**URGENT MEDICAL DEVICE CORRECTION**  
**Programmer Software Update**  
**Supporting the Micra™ Transcatheter Pacing System**

| Model   |
|---|
| 2090 CareLink™ Programmer<br>29901 Encore™ Programmer<br>CareLink Network Application Software 2491 |

17 January 2019

Image 1

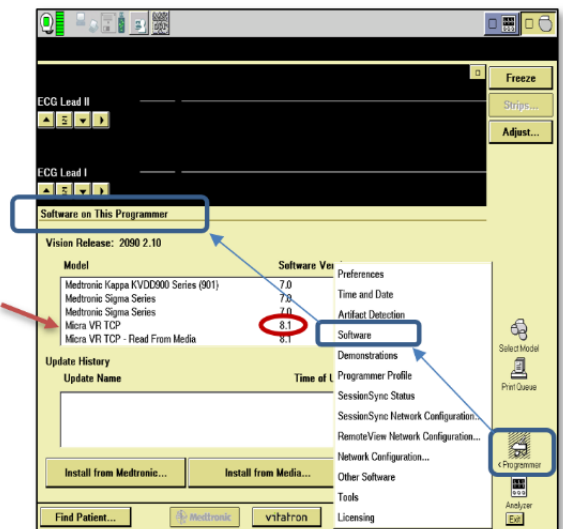
#### Correct software: Micra VR TCP version 8.1 (or higher)

From the Programmer start-up screen CANCEL out of the Find Patient window and Select the Programmer icon along the right-hand side of the programmer display:

- Select Software (see image 1)
- Scroll through the list of available Software Models in the top selection box until you locate the Micra selection
- Verify the Software Micra VR TCP Version is 8.1

Images 2a and 2b

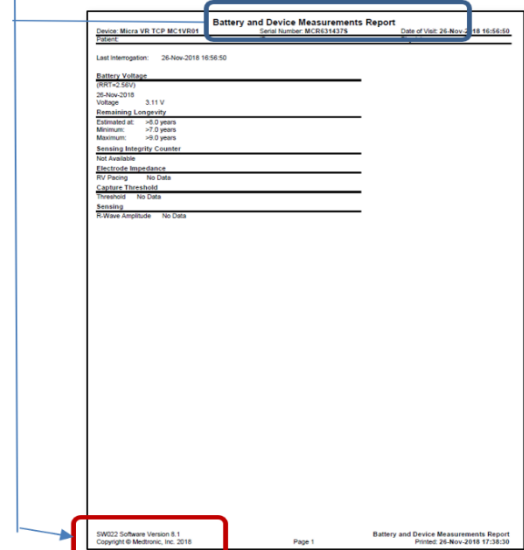
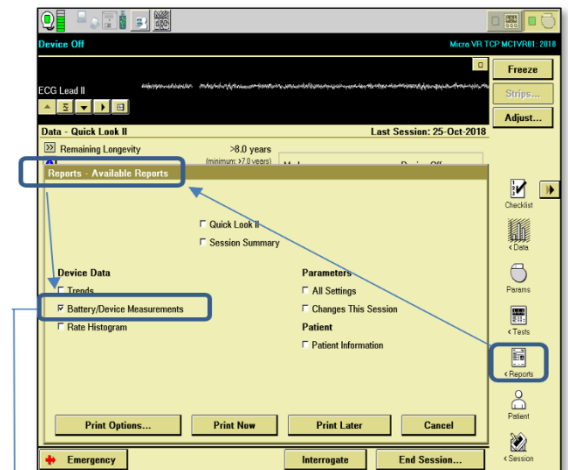
Any CareLink transmission completed after **January 17, 2019** will report the updated remaining longevity estimate. For in-clinic patients who have been interrogated via a programmer, the clinician can view the Battery and Device Measurements Report (Images 2a and 2b) and verify that the Software Application Model ID located in the lower-left corner of the report indicates "SW022 Software Version 8.1".

- Select Reports (see image 2a)
- Select Battery/Device Measurements
- Click Print Now
- Verify the software version printed on the lower left-hand corner is "SW022 Software Version 8.1"
